Fire Department – Steve Smith:

DISAPPROVED COMMENTS:

FIGURE 8

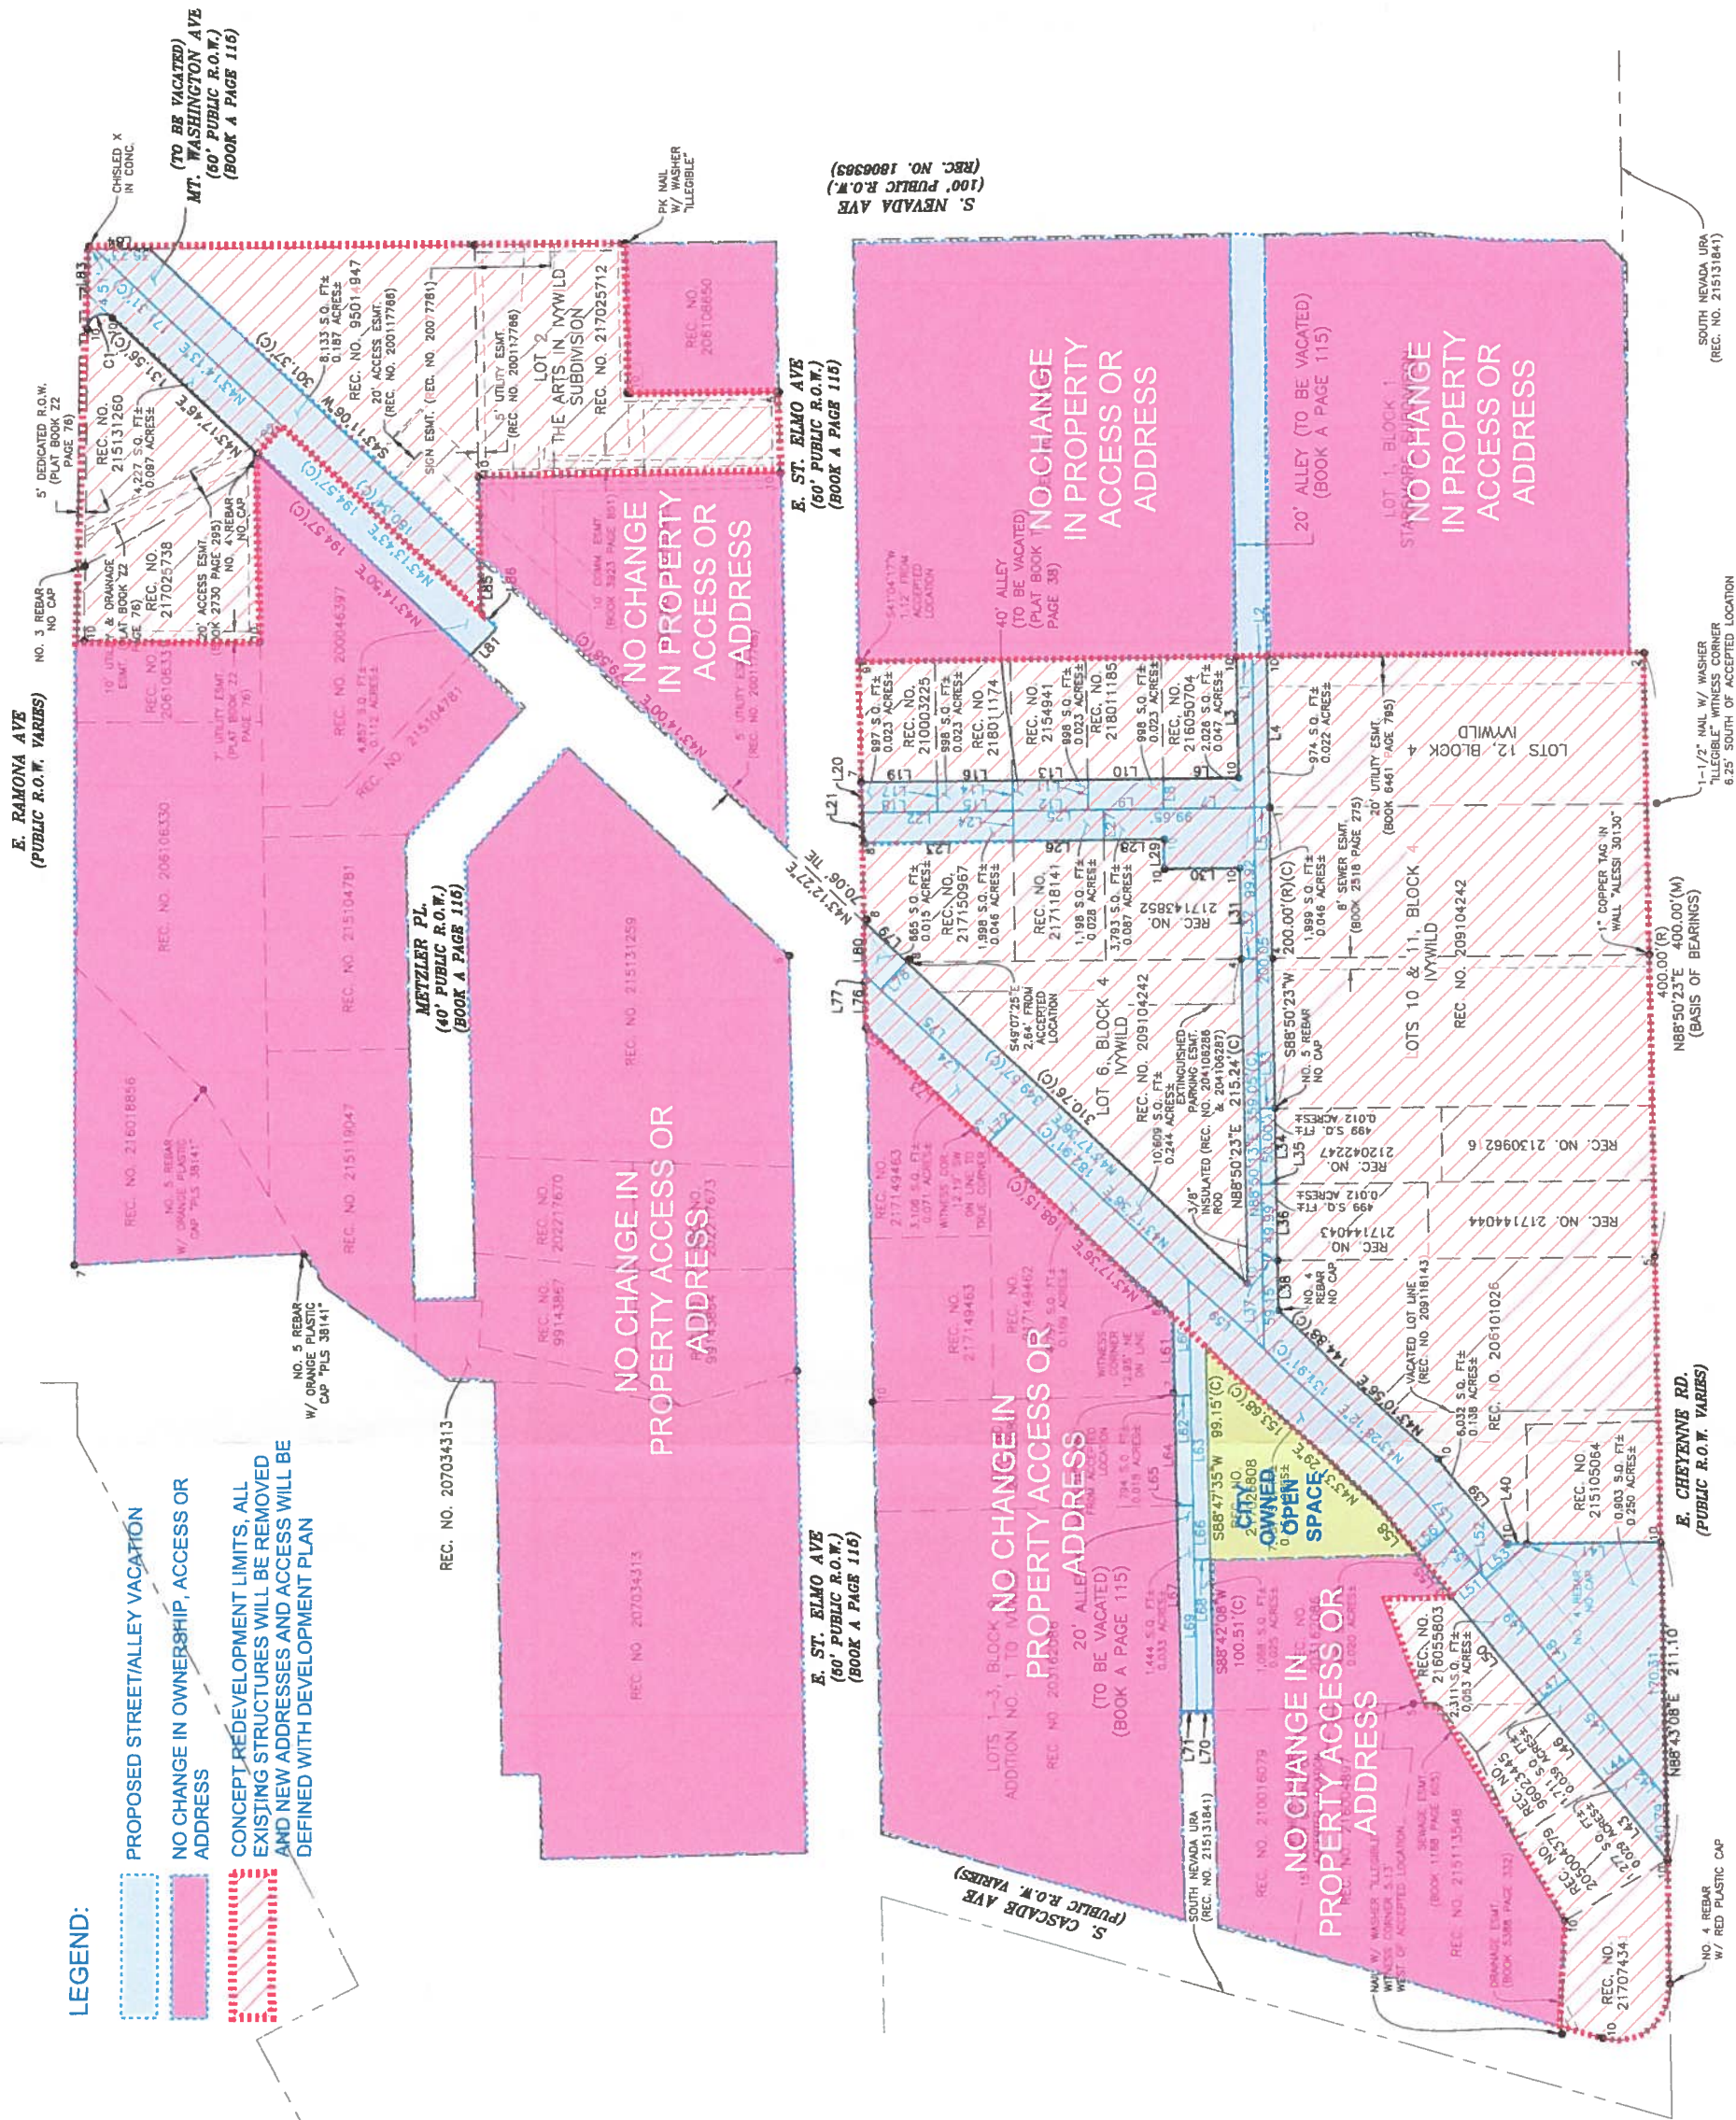
Provide an exhibit that shows all buildings (and addresses) that will remain after the proposed vacations. The concern is legal access to these locations as well as addressing of these locations. Should the ROW be vacated, the address might be impacted. Provide this analysis and exhibit to show that buildings that will remain will have legal access to public ROW and their addresses will not be impacted. **Response- exhibit to show access to remaining buildings/ address impacted.** Plans are not clear enough in terms of what exactly is being proposed for vacation. There are some areas marked as "To be vacated" and other areas that are not marked. Provide plans that clearly show what is being vacated. **Response -Additional graphic to indicate vacation limits and access. See enclosed plan exhibit.**
